STORE PROPERTY INVESTMENTS LTD
LAND WEST OF BROOK LANE AND
SOUTH OF A259
RUSTINGTON

ROAD SAFETY AUDIT RESPONSE
REPORT
STAGE 1 - ROAD SAFETY AUDIT

JUNE 2018

Project Code:	SPRust(BrookLane).1.
Prepared by:	OAN
Approved by:	VL
Issue Date:	June 2018
Status:	Final

scale	1:500@A3	drawn by	OAN	checked by	VL
date	JUNE 2018	cad file	TK08.DWG		
drawing number	SPRUST(BROOK LANE).1/TK08				rev.

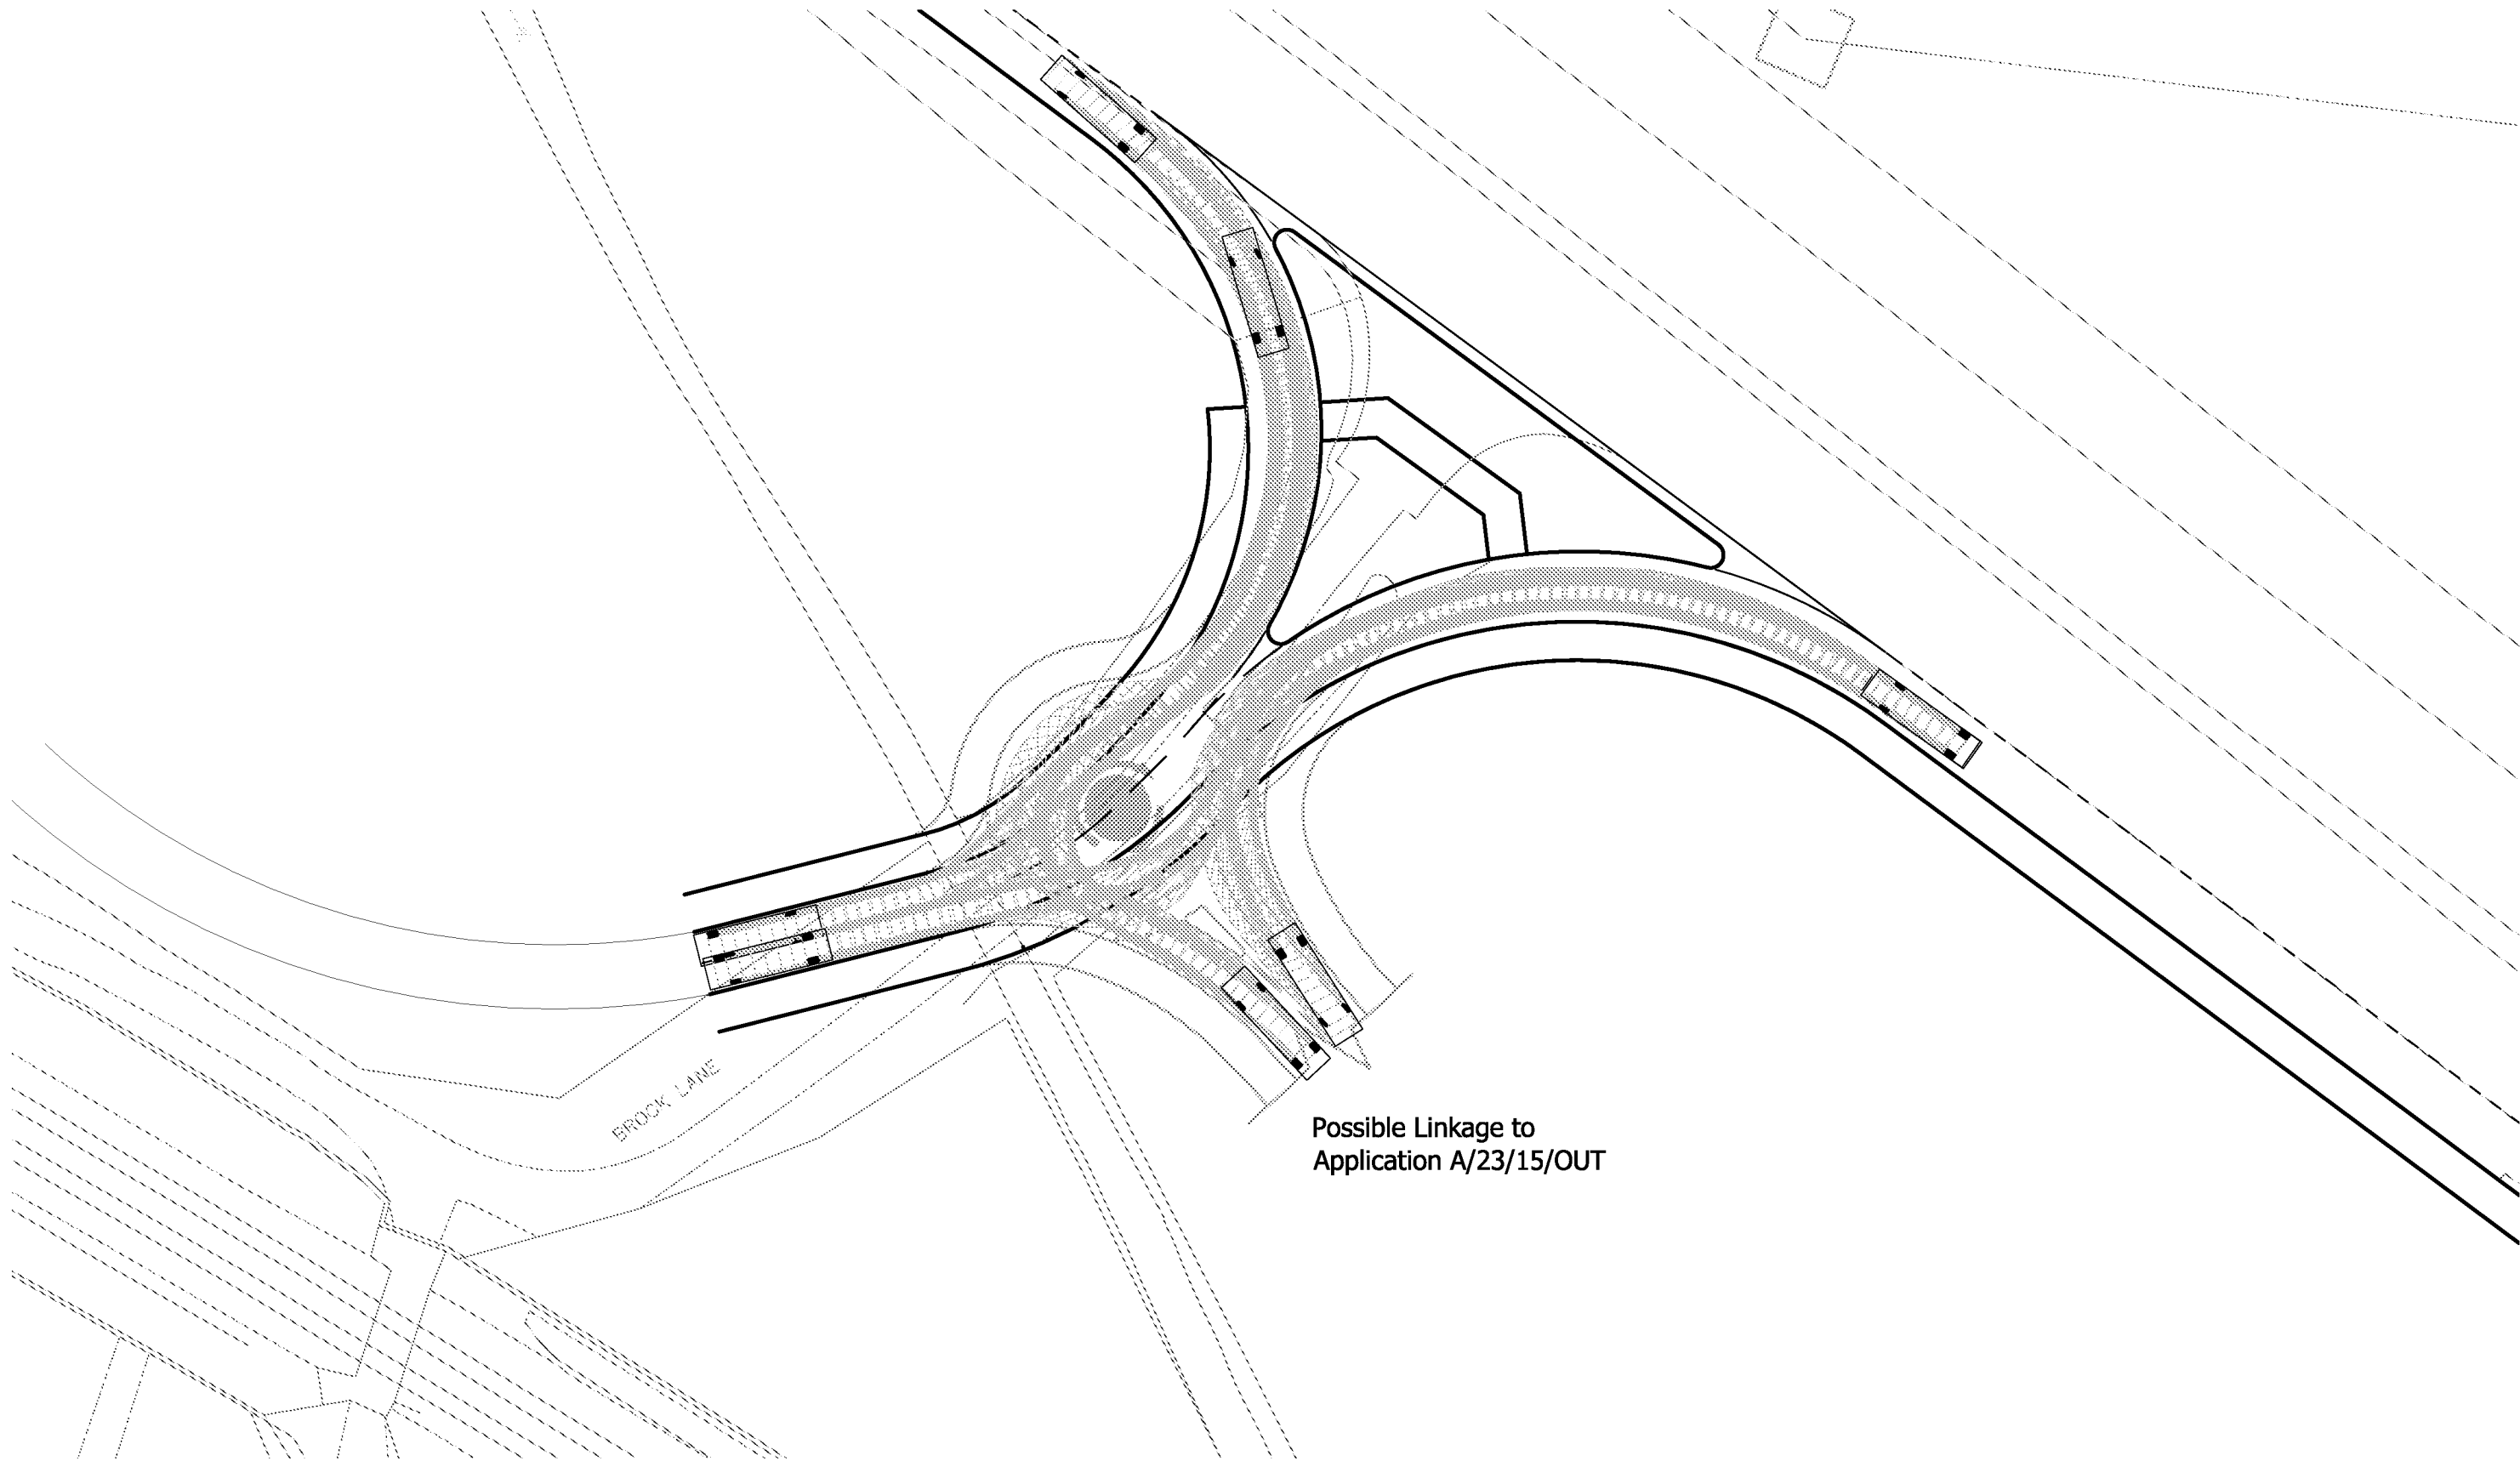
Summary: Servicing Arrangements

Details of swept paths have not been provided. It is important that all anticipated vehicles can access the site appropriately without traversing the footway or requiring excessive reversing manoeuvres.

Undertake swept path analysis using anticipated vehicles to ensure that the vehicles can access the site appropriately.

This is agreed, swept path plots of both a single deck bus and a 16.5m articulated vehicle are included at **Appendix C**. The swept path plots demonstrate that both vehicles can enter and exit the roundabout from all directions.
